**Adapting Option 30 to fit the Cotswolds National Landscape**

**The A417 Missing Link at the Air Balloon**

### **Outline Representation Sept 2021**

**A417 Missing Link at the Air Balloon**  
**Response to**  
**Highways England Supplementary Consultation**  
**13<sup>th</sup> October - 12<sup>th</sup> November 2020**

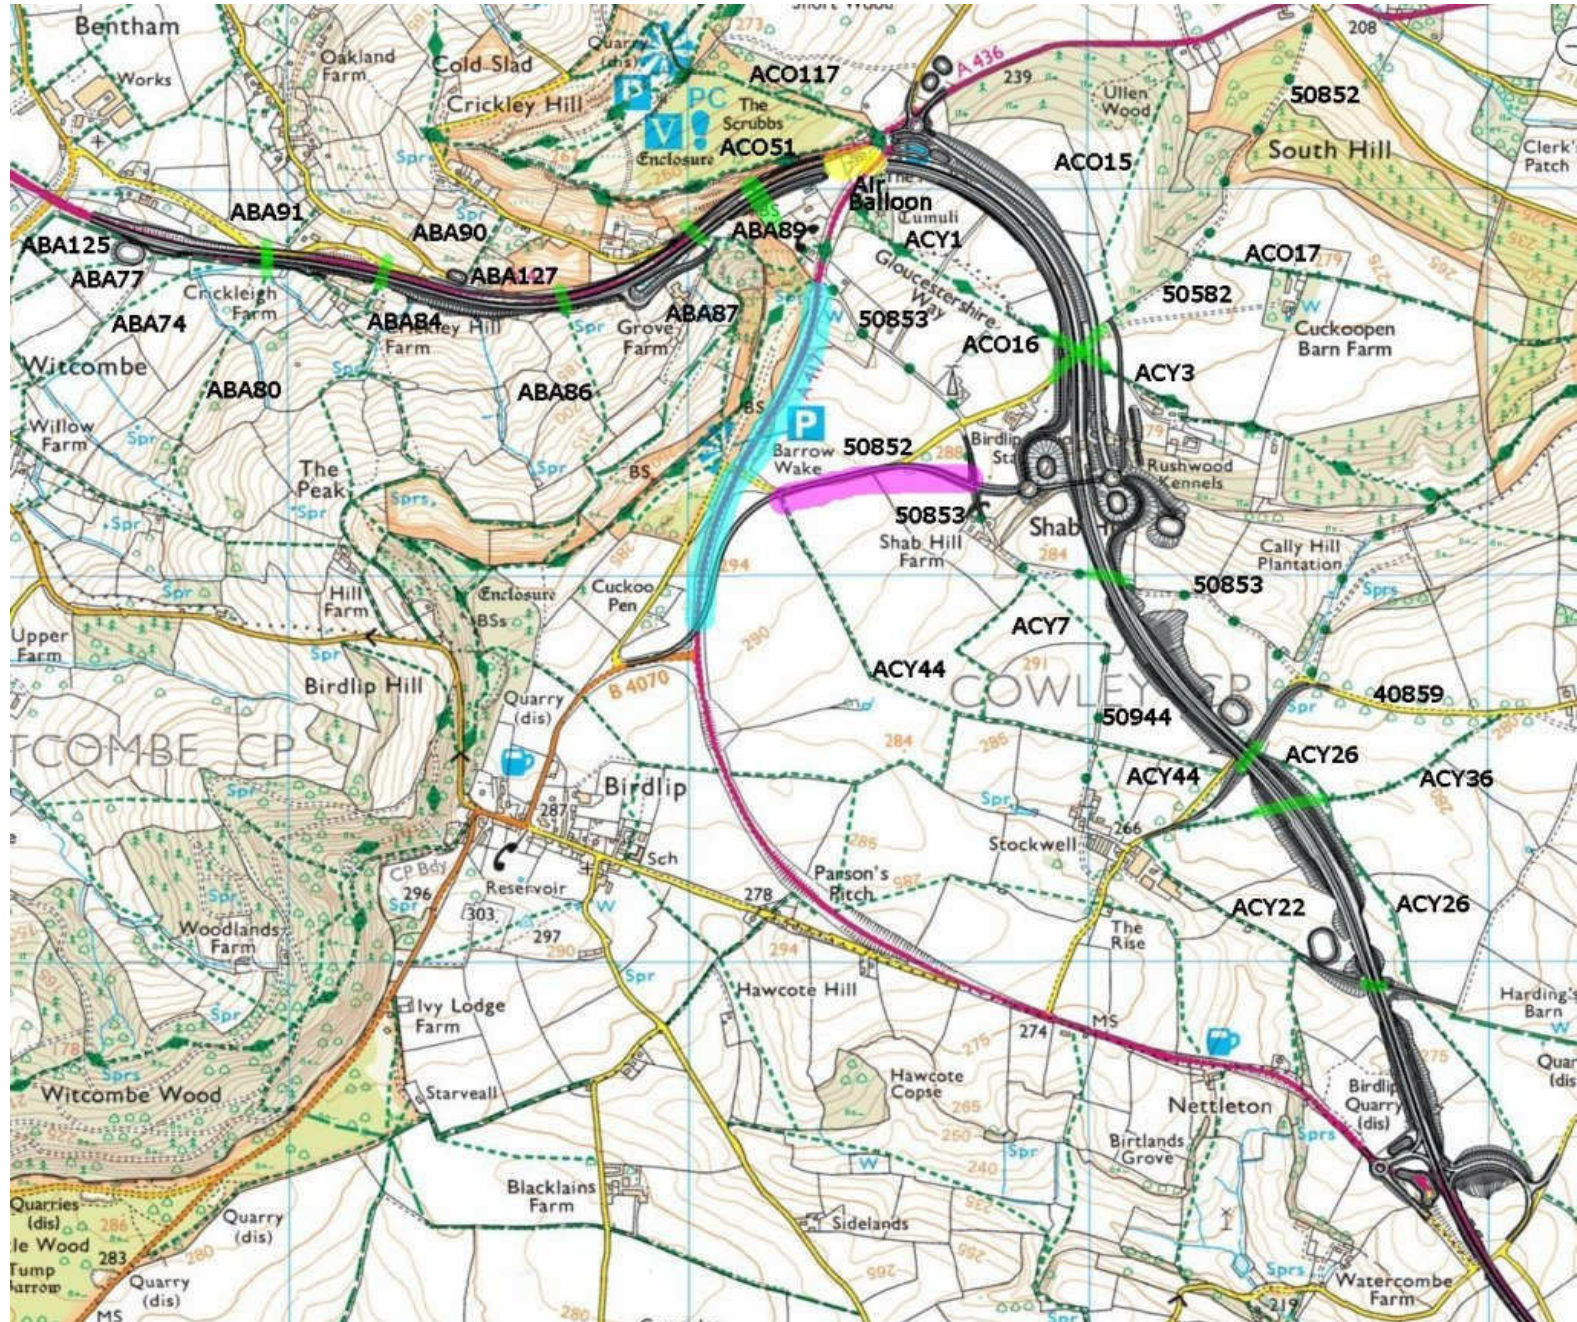
To improve the scheme, a 150 metre Green Bridge (yellow) could retain the Air Balloon Inn, allow access to nearby properties & keep the Cotswold and Gloucestershire Ways in place. The current road past Barrow Wake (cyan) could be returned to Calcareous Grassland.
